ATTENDED PLAN SHOWING ADDITION OF EXTRA BAY TO NORTH WING.

WELLINGTON CENTRAL LIBRARY.

DRAWING NO. O.

NOTE: AN ADDITIONAL BAY IS TO BE INTRODUCED IN THE LENGTH OF THIS NORTH WING AS INDICATED ON THE AMENDED PLAN DRAWING NO. O.
THIS WILL BE A COMPLETE MODIFICATION OF THE BAY INCLUDED WITHIN THE RECTANGLE A B C D.

FOUNDATION PLAN.

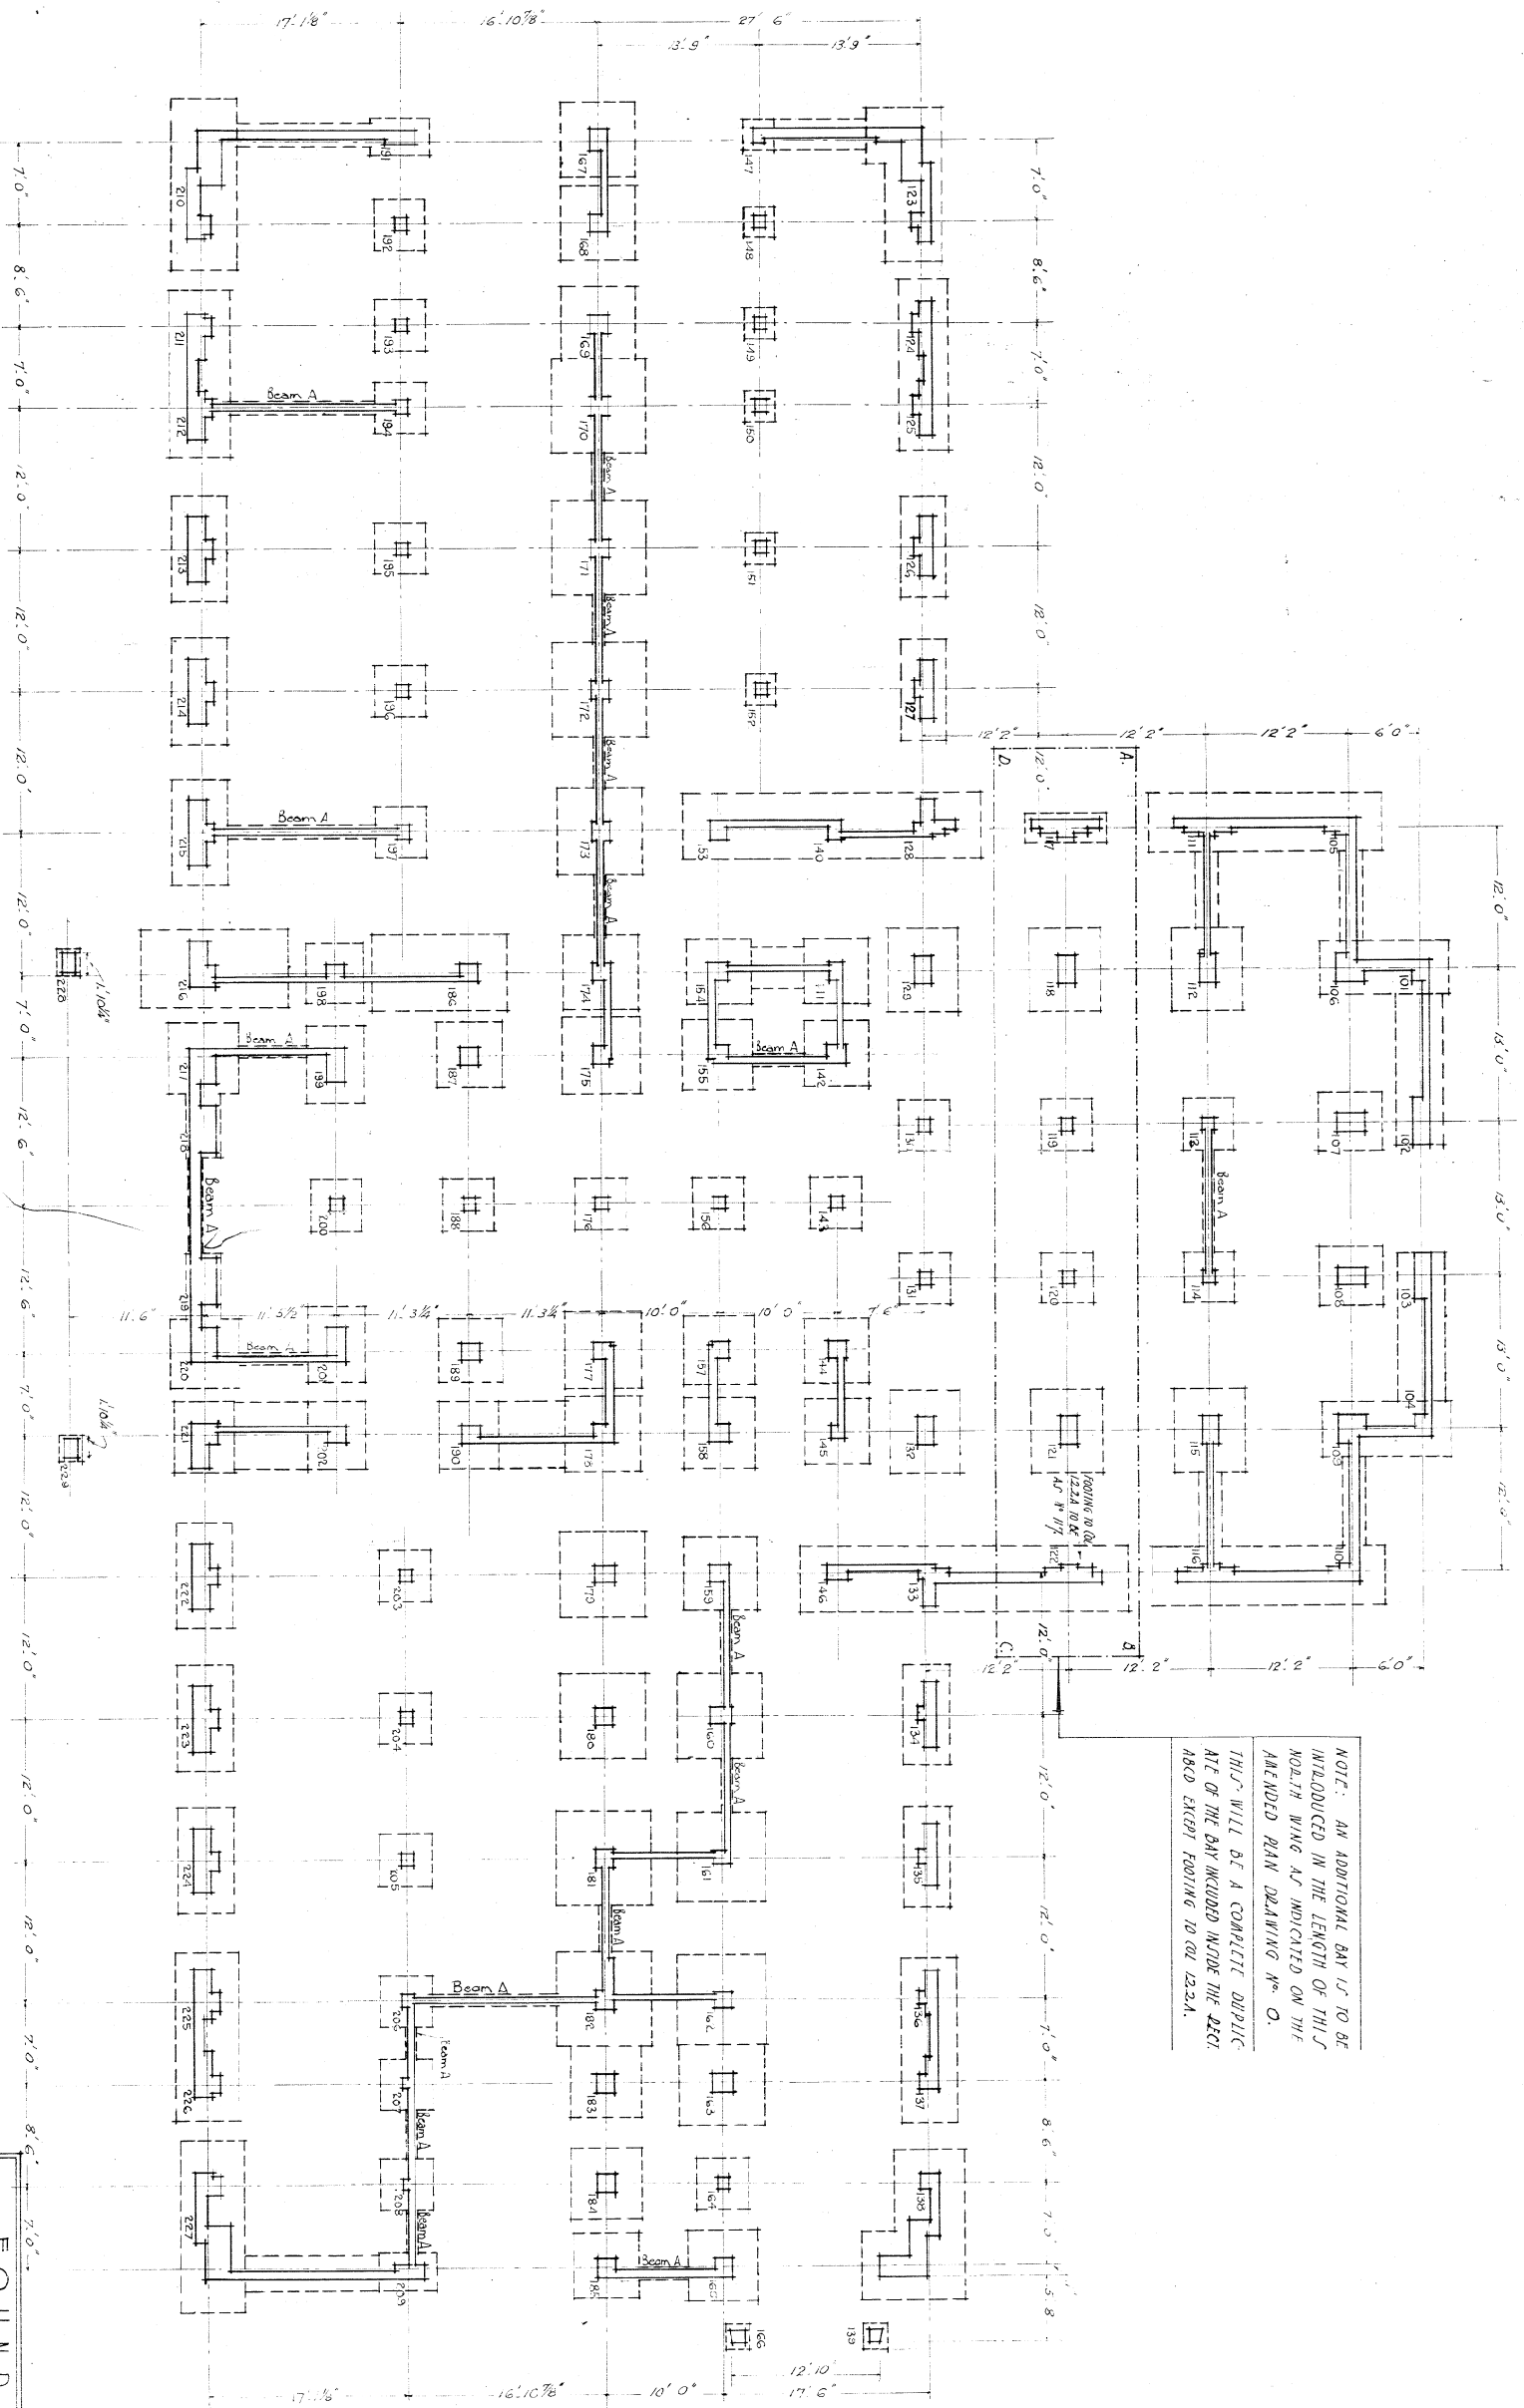
NOTE: AN ADDITIONAL BAY IS TO BE INTRODUCED IN THE LENGTH OF THE NORTH WING AS INDICATED ON THE AMENDED PLAN DRAWING NO. O. THIS WILL BE A COMPLETE DUPLICATE OF THE BAY INCLUDED INSIDE THE RECTANGULAR FOOTING TO COL. 123.2A.

BASMENT FLOOR FRAMING PLAN.

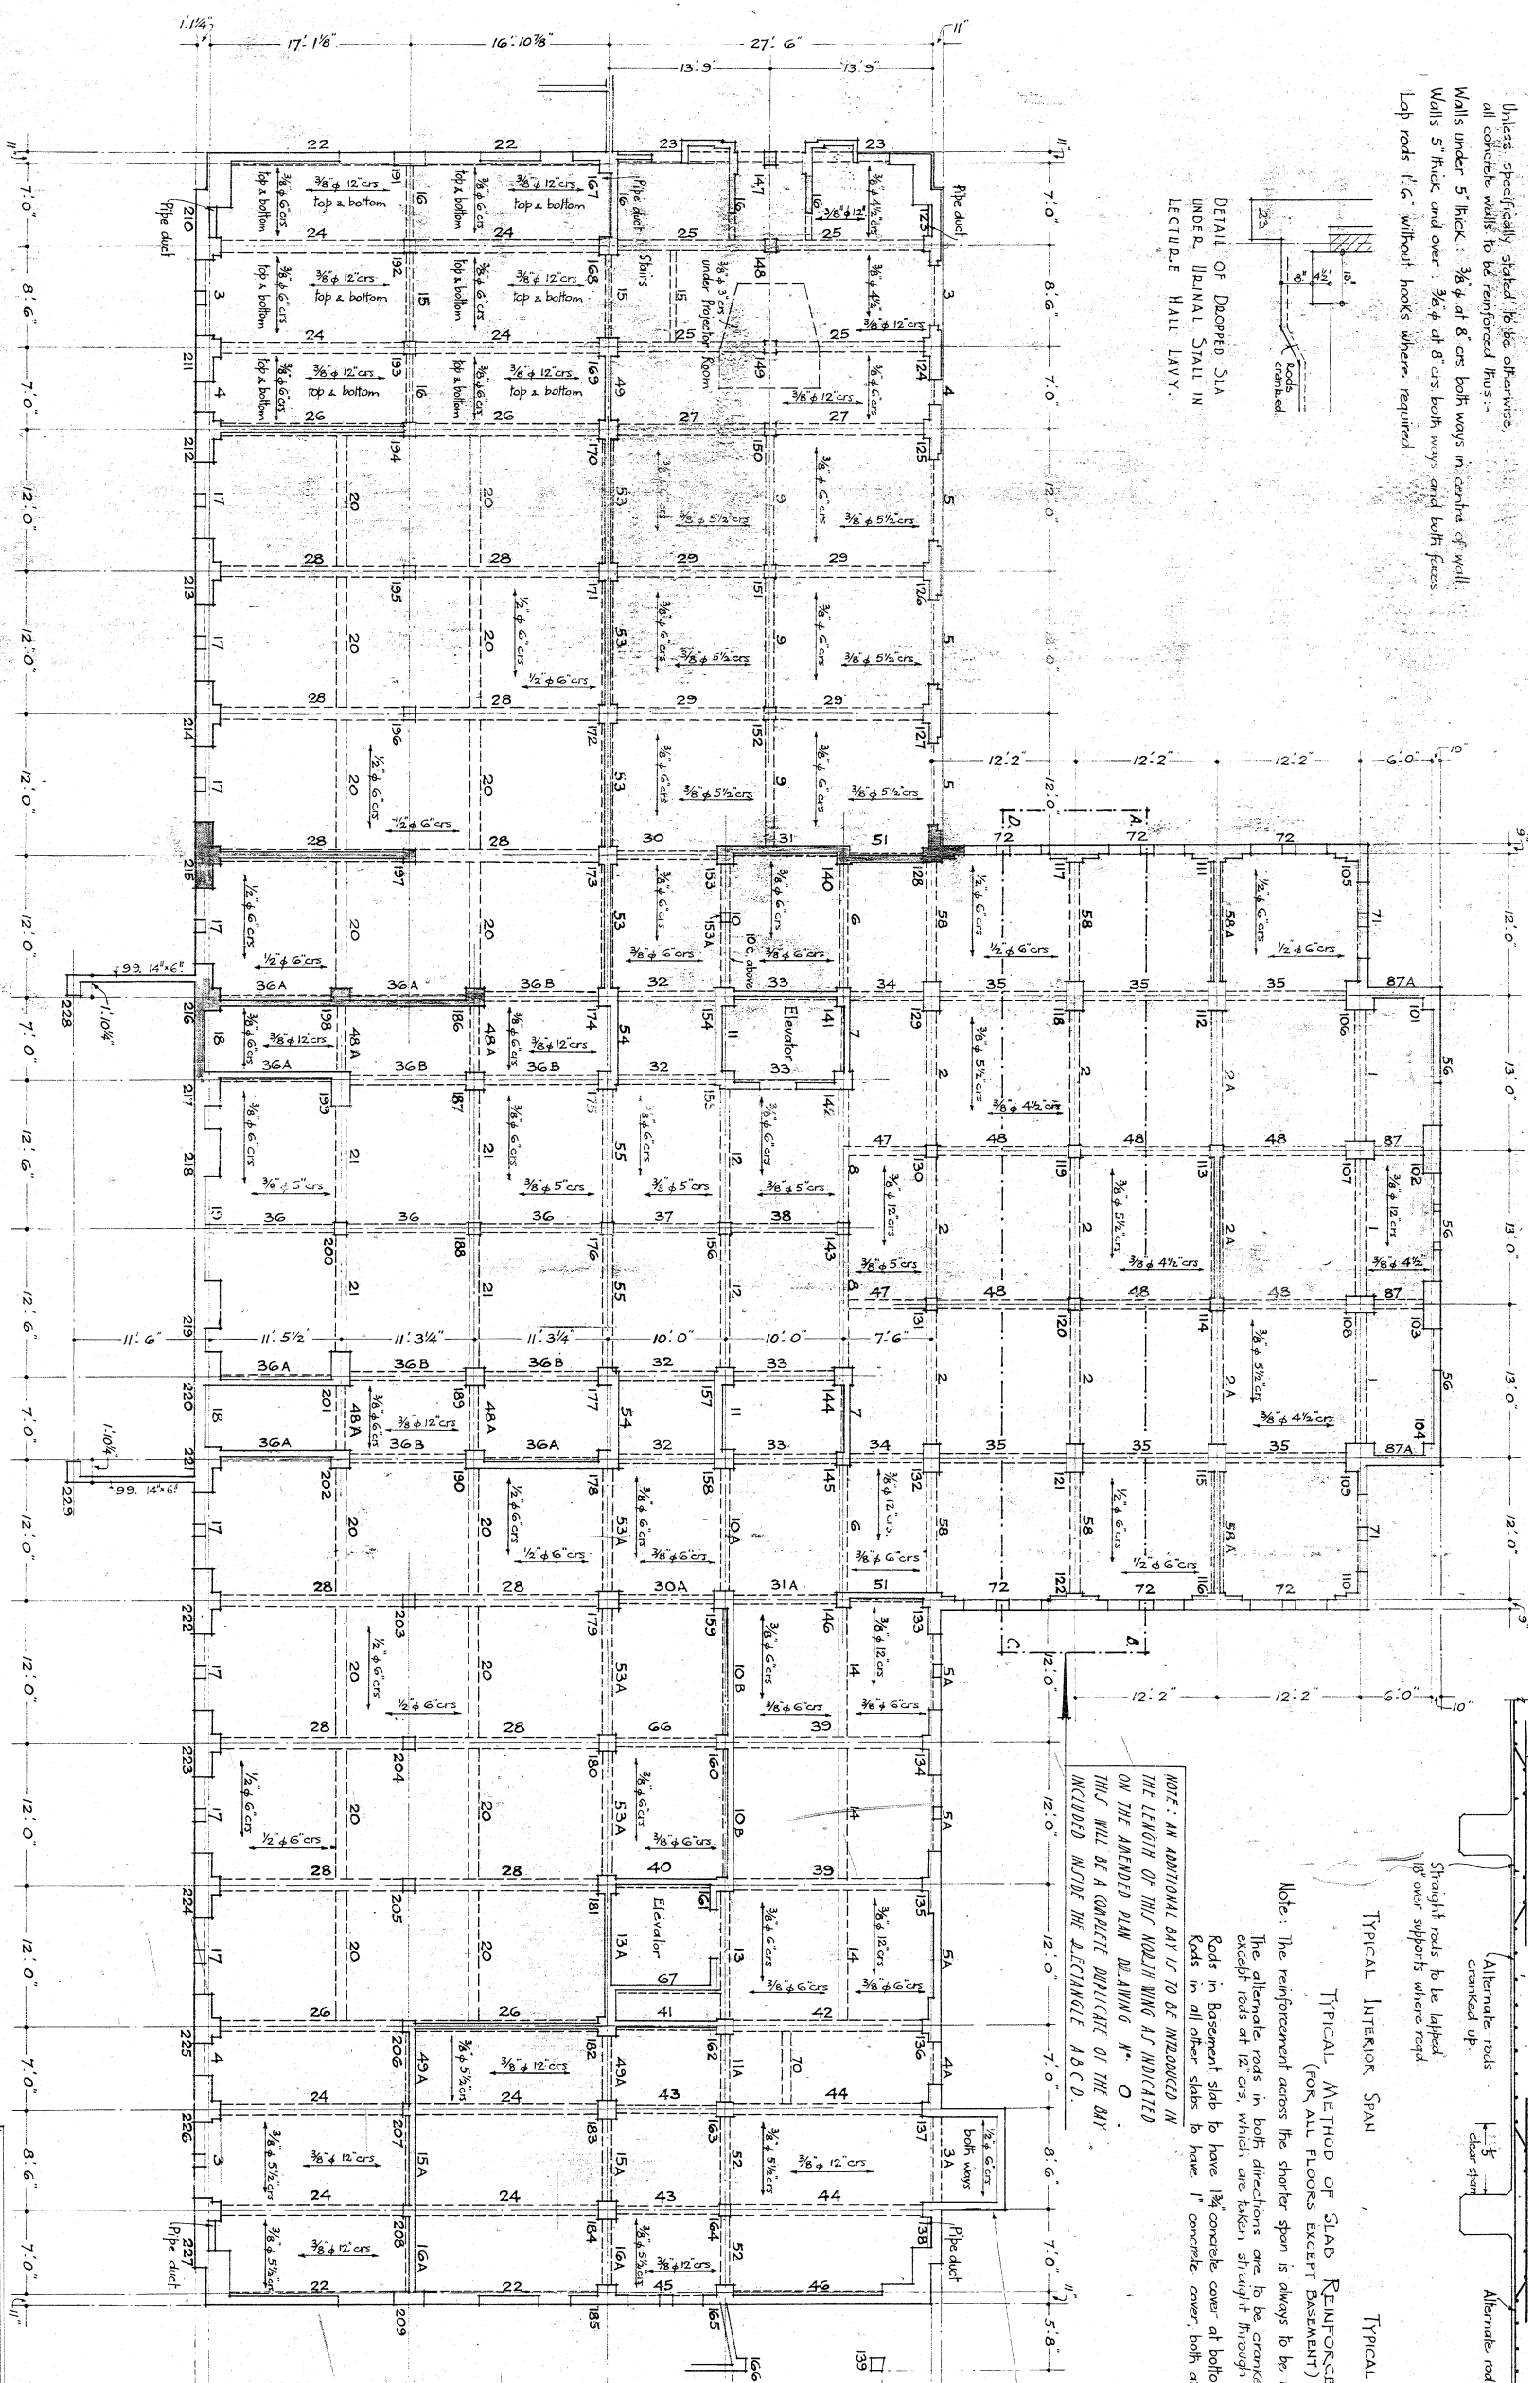
NOTE: AN ADDITIONAL BAY IS TO BE INTRODUCED IN THE LENGTH OF THIS NORTH WING AS INDICATED ON THE AMENDED PLAN DRAWING N. O. THIS WILL BE A COMPLETE DUPLICATE OF THE BAY INCLUDED ABOVE THE TRIANGLE ABCD.

GROUND FLOOR FRAMING PLAN.

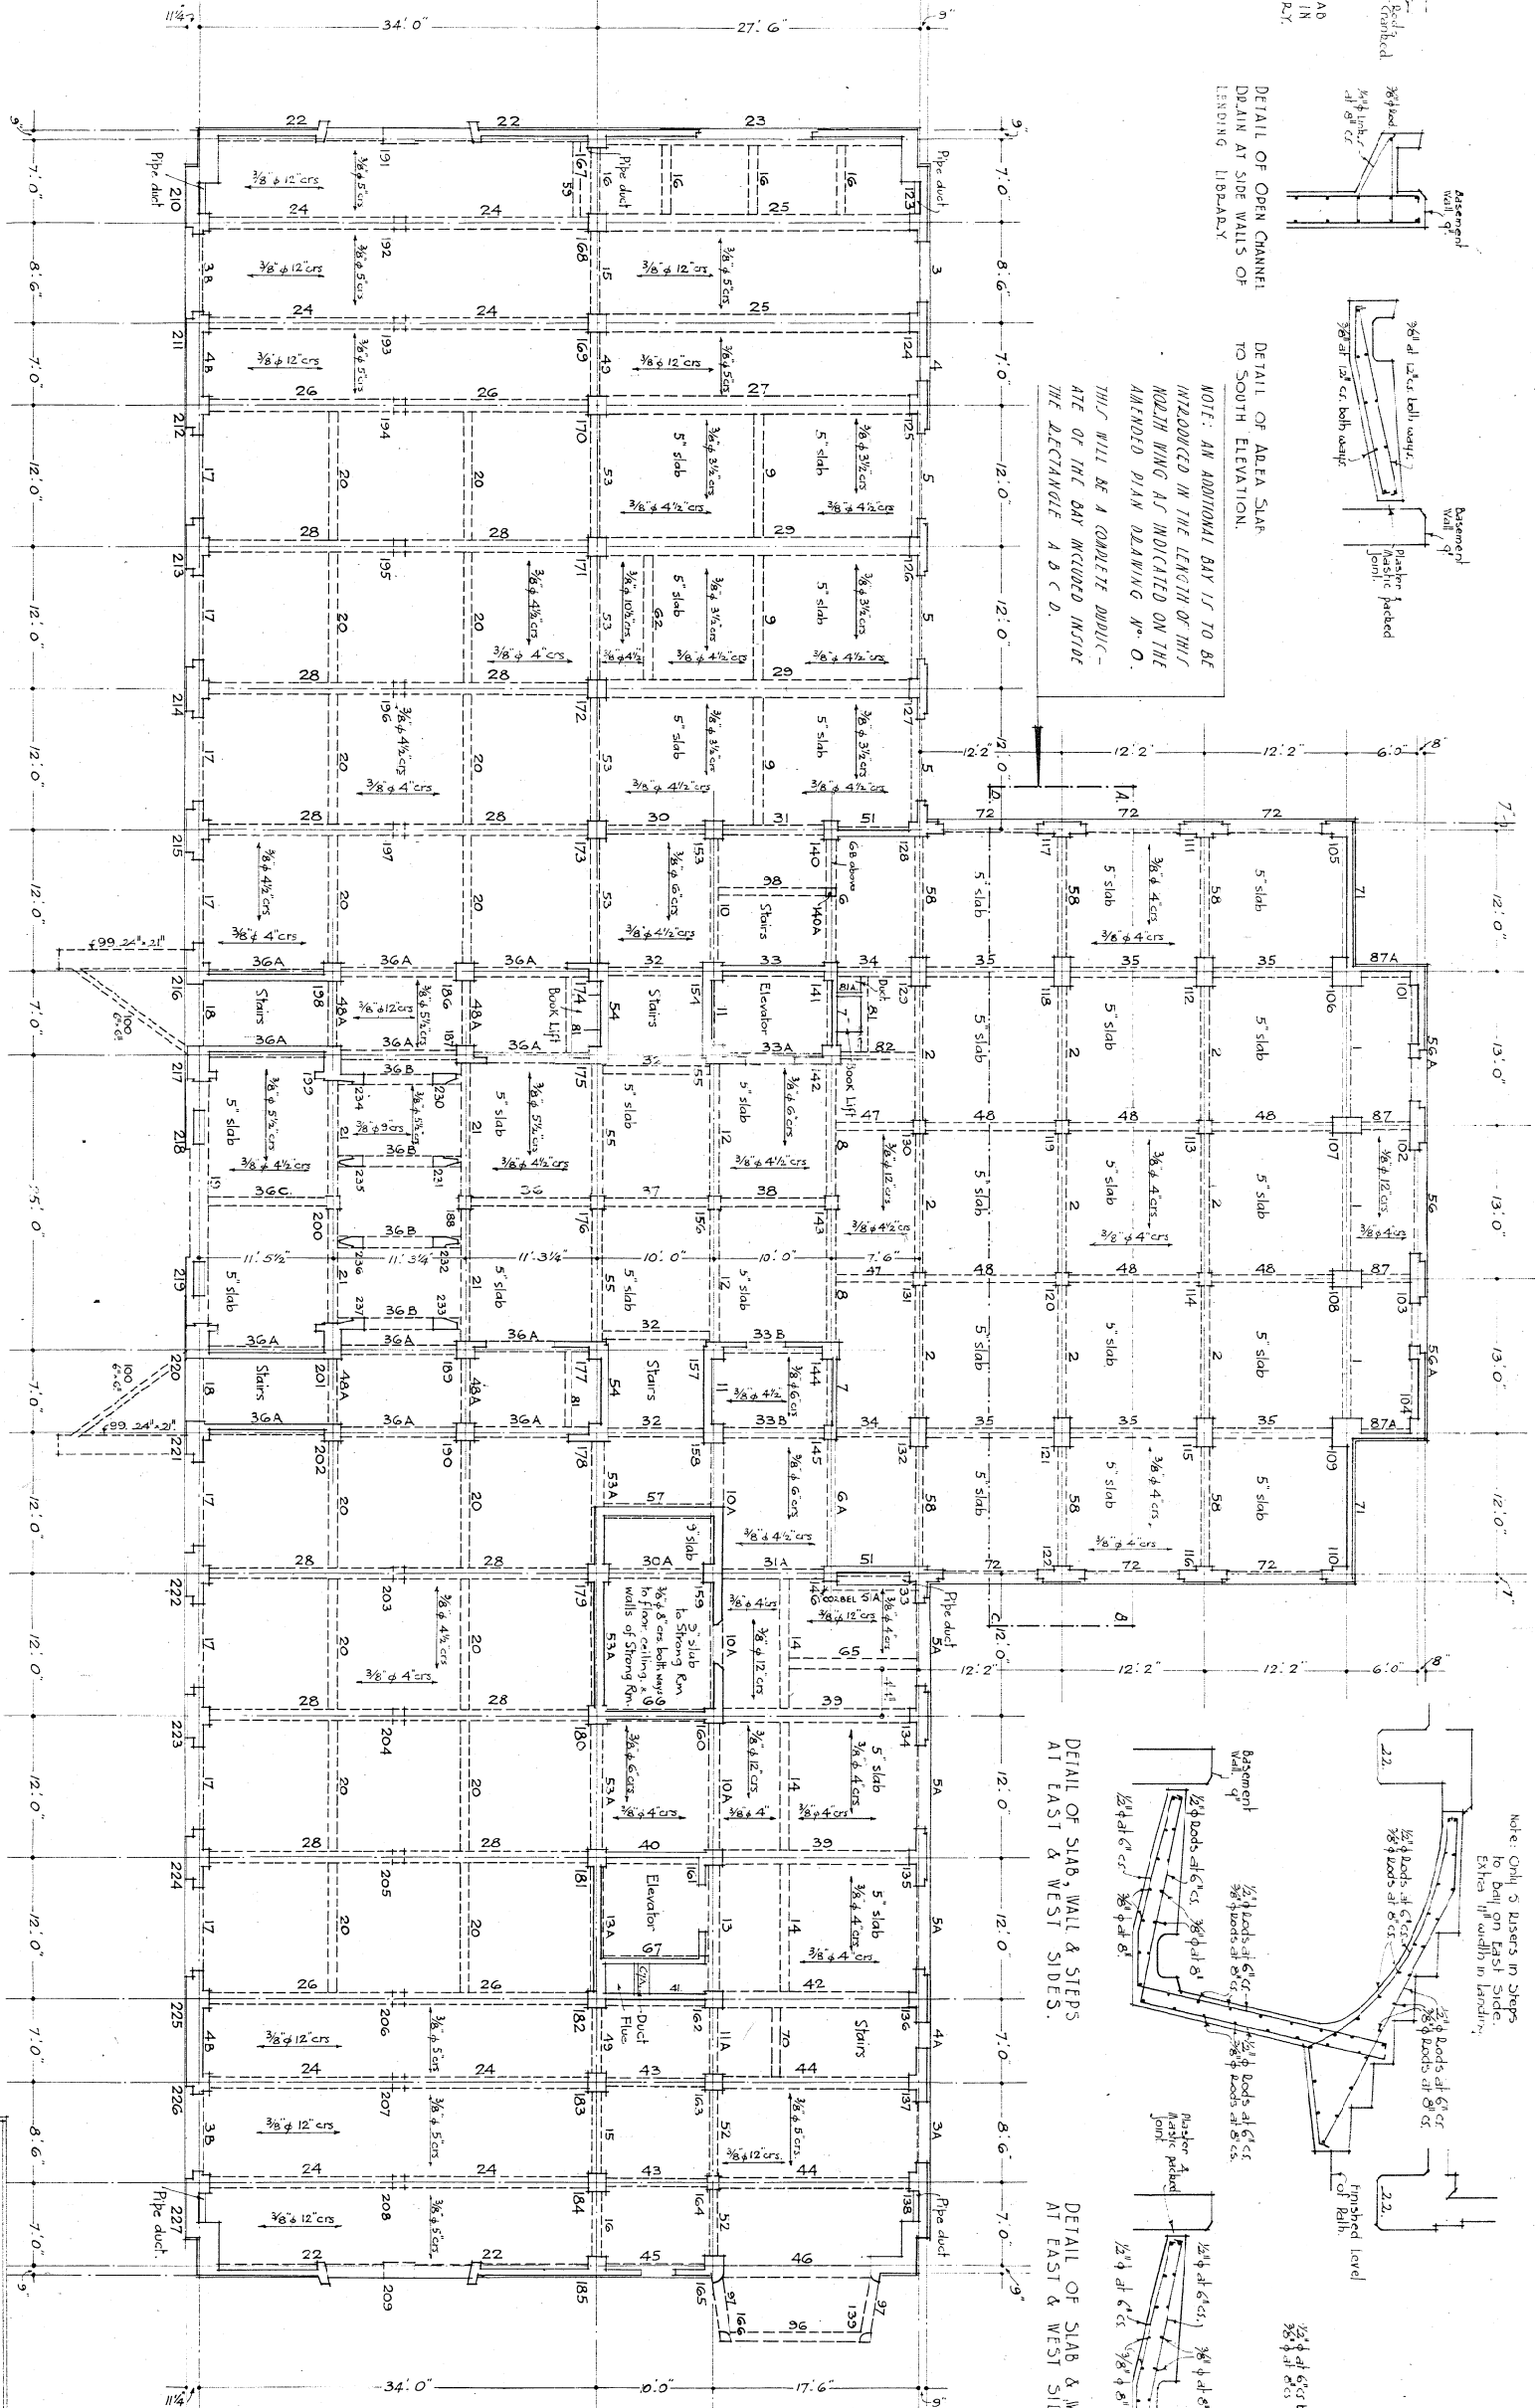
NOTE: AN ADDITIONAL BAY IS TO BE INTRODUCED IN THE LENGTH OF THIS NORTH WING AS INDICATED ON THE APPROVED PLAN DRAWING N.O. THIS WILL BE A COMPLETE DUPLICATE OF THE BAY INCLUDED INSIDE THE RECTANGLE A B C D.
